| T.I. no.: 2018 - 17 Updated: - | Topic: New mains water supply |

| Affected machines: SCP |

NEW MAINS WATER SUPPLY

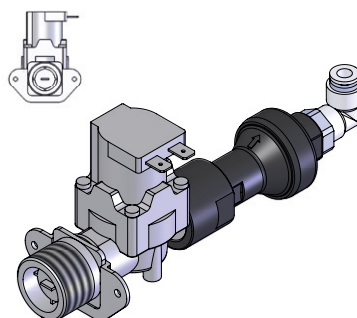
The mains water supply of the SCP (072838) has been revised. The pressure valve (33.2269.3000) does not always work consistently and is being replaced by an inline controller.

Old pressure valve (33.2269.3000)

New inline controller (072838)

The module is only available as a complete unit since it is stored in a pre-assembled state. The new module can be retrofitted. To do so, order part no. 072838 and exchange the complete module.
